**Southern Nuclear Operating Company  
Vogtle Electric Generating Plant Units 3 and 4  
Request for License Amendment and Exemption:  
Clarification of ITAAC Regarding In vessel Components (LAR-21-001)**

**Clarification of ITAAC Regarding Inessel Components  
(LAR-21-001)**

## **LICENSING BASIS CHANGE DESCRIPTIONS**

**Plant-Specific Tier 1 Section 2.5.5, Design Description, item 3.b, is revised (related to ITAAC 570) as follows:**

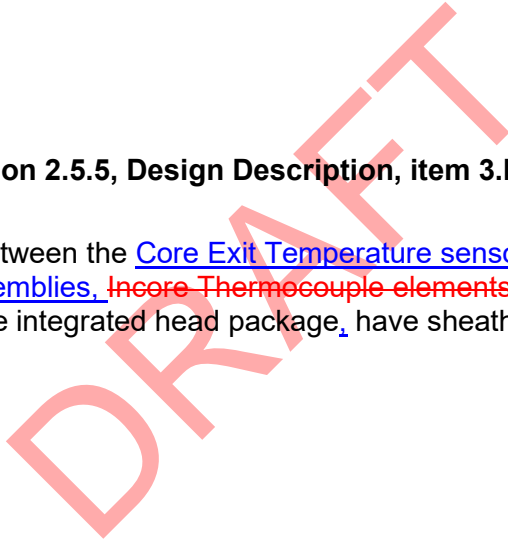
It is requested that the Design Description, item 3.b) (supporting ITAAC 570), be revised for clarity, and that ITAAC 570, item 3.b) be revised for clarity and to remove the "as-built" attribute of the inspection. To give effect to the scope of this ITAAC expressed by NRC staff, the clarity changes include replacing the phrase "Incore Thermocouple elements" with "Core Exit Temperature sensors" for consistency with other ITAAC nomenclature, adding additional "location" information, and replacing "system" with "Class 1E cables" so that the inspection language is consistent with the Design Commitment and the Acceptance Criteria.

- Revise Design Description item 3.b) to clarify the scope of the Design Commitment.

- Revise Design Description item 3.b) to clarify the scope of the Design Commitment.

- b) The Class 1E cables between the Core Exit Temperature sensors, which are located within the Incore Thimble Assemblies, ~~Incore Thermocouple elements~~ and the connector boxes, which are located on the integrated head package, have sheaths.
